Development Application Accessibility Review Shore Physical Education Centre & Bishops Gate Carpark Blue Street, North Sydney NSW

Report Prepared for: Cox Architecture – Alex Small
Report Prepared by: Lindsay Perry
Report Reference: AN16-206579 20160420 DAR-REV1_LP.docx
Our Ref: AN16-206579
Client Ref: 213204
Date: 27 May 2016

Document No	Title	Revision
A-DA-0012	Site Plan Proposed	01
A-DA-2100	Lower Ground Floor Plan	01
A-DA-2110	Ground Floor Plan	01
A-DA-2120	First Floor Plan	01
A-DA-2130	Second Floor Plan	01
A-DA-2140	Third Floor Plan	01
A-DA-2150	Fourth Floor Plan	01
A-DA-2190	Bishops Gate Ground Floor Plan	01
A-DA-2121	Bishops Gate First Floor Plan	01

LOWER GROUND FLOOR
PLAN_RL55.00

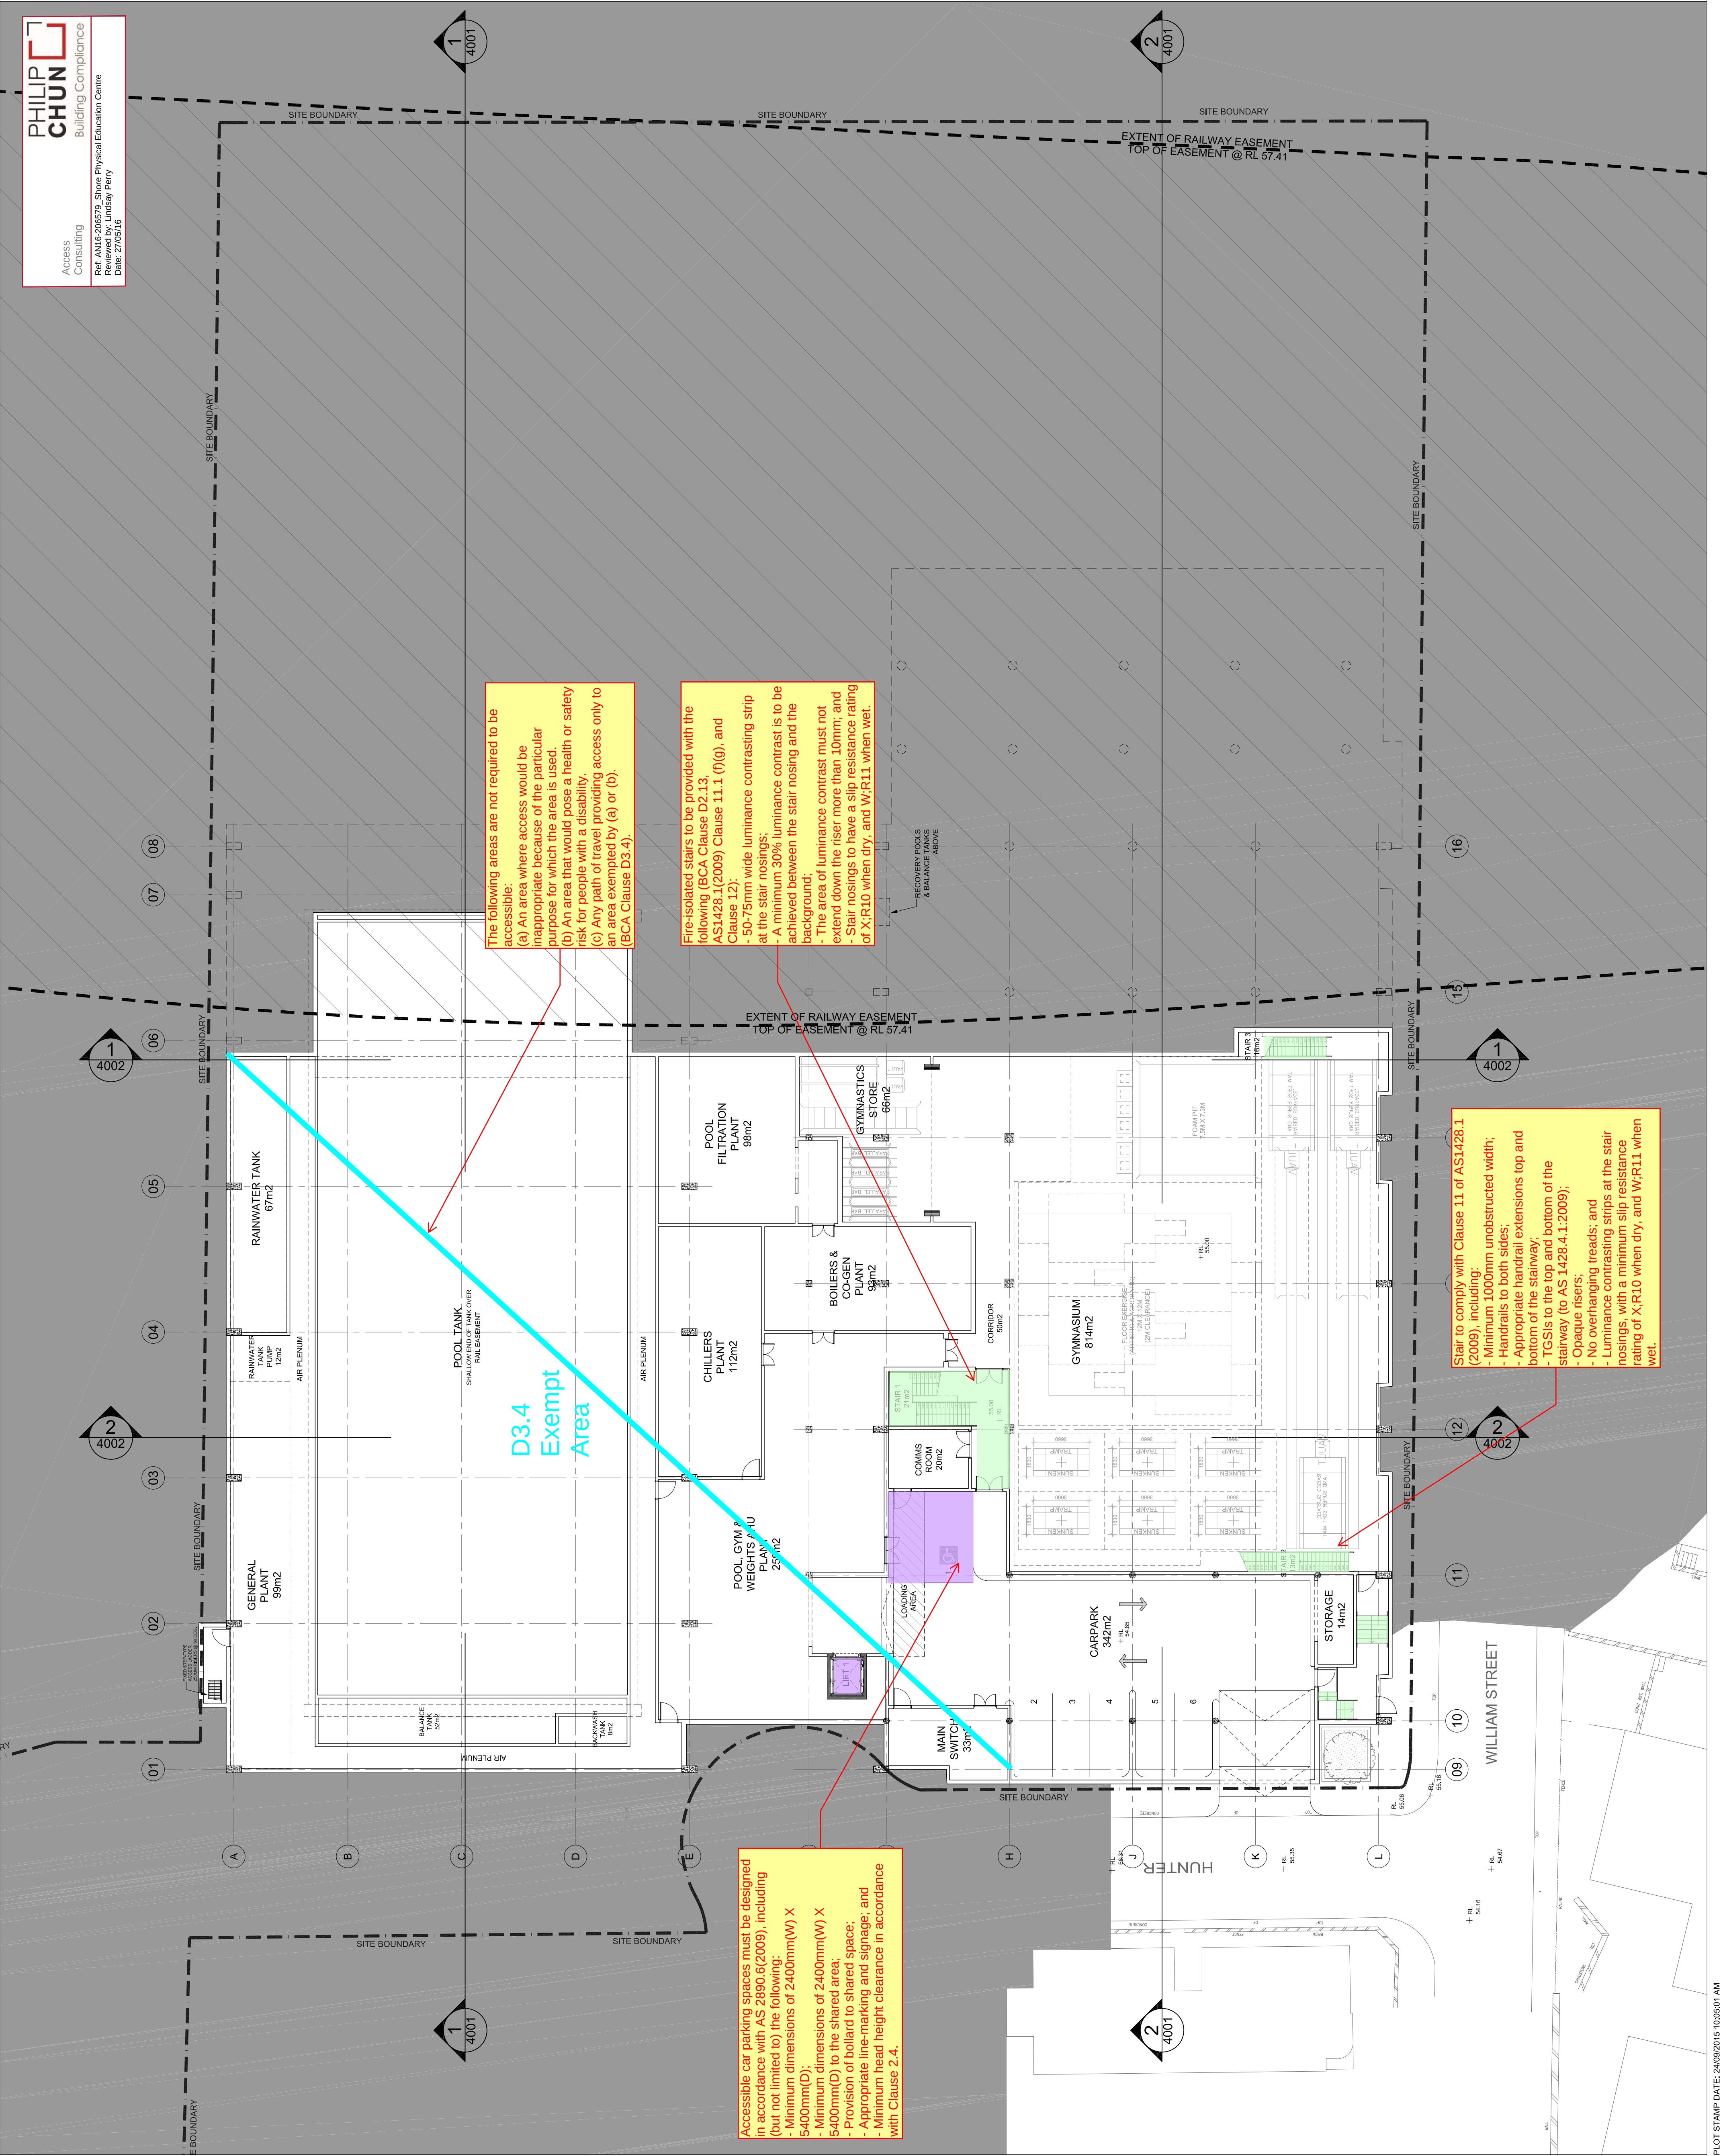
Drawings indicate that doorways are generally provided with adequate circulation areas for compliance – refer to marked plans for exceptions. This will be addressed in subsequent design stages. For additional compliance requirements, refer to Appendix B.
